Work Order ID 135692

Item Name: Fwd Crosstube - Mid Height 206L / L1 / L3 / L4, Blue

DRAWING NO. D206-667-147	TITLE CROSSTUBE ASS'Y (206L MID FWD)	REV. A	DART AEROSPACE LTD ENGINEERING ORDER		D.E.O. NO. D206-667-147-A-1	SHEET NO. SHEET 1 OF 1	SCALE NTS
DRAWN <i>ap</i>	CHECKED <i>ASS</i>	MFG. APPR. <i>ES</i>	APPROVED <i>MD</i>		DE APPR. <i>HT</i>		
DATE 11.07.15	DATE 11.07.20	DATE 11.07.21	DATE 11.07.21		DATE 11.07.21

DRAWING NO. D206-667-147	TITLE CROSSTUBE ASS'Y (206L MID FWD)	REV. A	DART AEROSPACE LTD ENGINEERING ORDER		D.E.O. NO. D206-667-147-A-2	SHEET NO. SHEET 1 OF 1	SCALE NTS
DRAWN AJS	CHECKED	MFG. APPR.	APPROVED	DE APPR.			
DATE 12.08.02	DATE 12.08.02	DATE 12.08.02	DATE 12.08.02	DATE 12.08.02	DATE 12.08.02

DETAIL P
BONDING STRAP INSTALLATION 2 PL

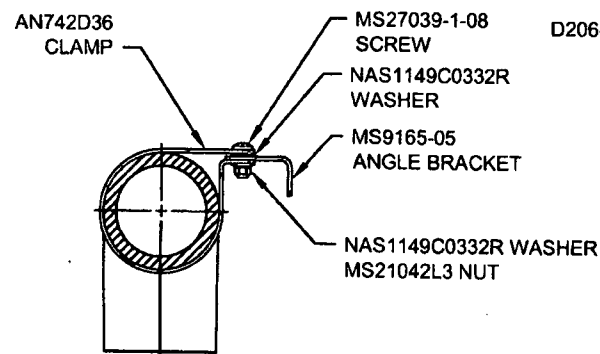
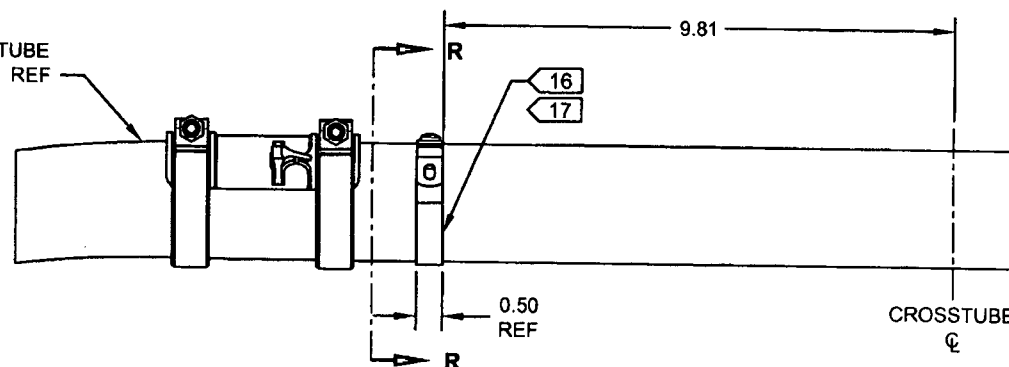
ADD ELECTRICAL GROUNDING STRAP

ADD

- 16) MASK AREA UNDER CLAMP PRIOR TO PAINTING
- 17) SEAL EDGES WHERE AN742D36 CLAMP MEETS WITH THE CROSSTUBE USING SIKAFLEX-241/-291 OR MIL-S-8802 CLASS B2 OR PROSEAL 890 SEALANT
- 18) PERFORM RESISTANCE CHECK TO ENSURE MAX RESISTANCE IS 10 MILLIOHMS
